INSTRUCTION MANUAL:

MODELS SM 75-5X
and SM 75-5MX

KEPCO, INC.
131 - 38 Sanford Avenue
Flushing 52, New York

INSTRUCTION MANUAL CORRECTION

KEPCO LABORATORIES	
FLUSHING, NEW YORK	
ITEM: POWER UNIT	DES. J.R.G.
	APVD. described
MODEL SM-75-5	DATE M. CEA 11-15-61
DWG. No. C-M00786	CHKD J.P.K.

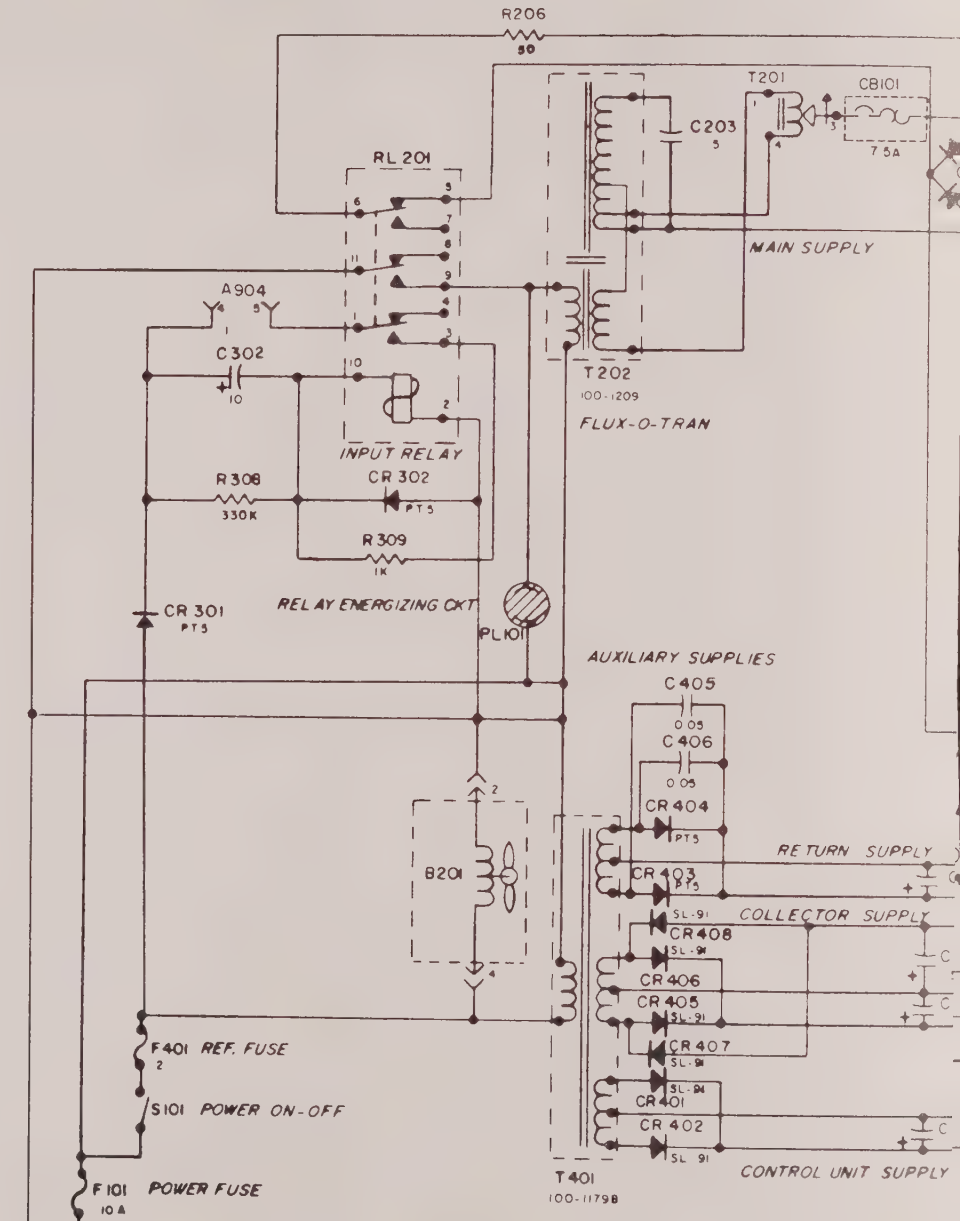
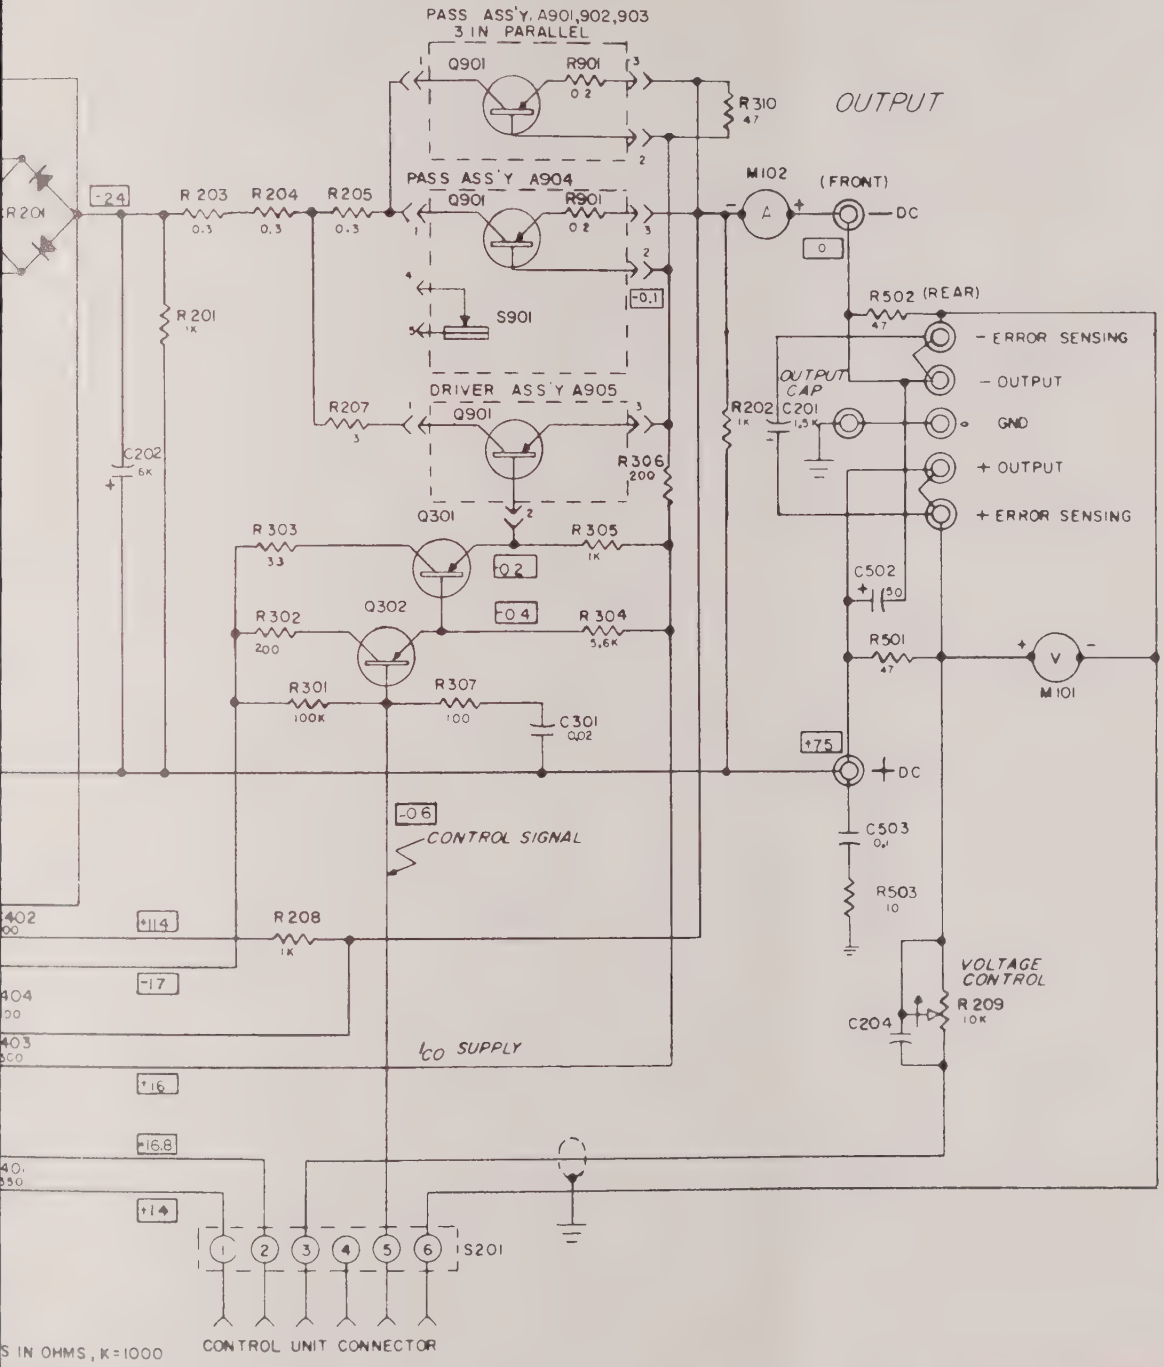
1. (c541) Change Resistor R206 from 50 ohms, to: Resistor, Fixed, Power, Strip; 25 ohms, 20 w, WW; Ward Leonard 20S25; Kepco #115-0757.

2. (c566) Change Kepco Part No. of Pass Assembly A901-A903 from 110-0124 to 110-0130. Change Kepco Part No. of Pass Assembly A904 from 110-0125 to 110-0131.

1. The two resistors, 47 ohms, 1/2 watt each, connected one from each Output terminal to its respective Error Sensing terminal, have been changed to: Resistor, Fixed, Power, Axial, 50 ohms, 3 w, 5%; Ward Leonard 3X50; Kepco #115-0641.

2. Silicon Diode CR 302 (PT-5) has been replaced by a resistor R 320; Resistor, Fixed, Axial, 2500 ohms, 3 w, 5%; Kepco #115-0469; Ward Leonard #3X2500.
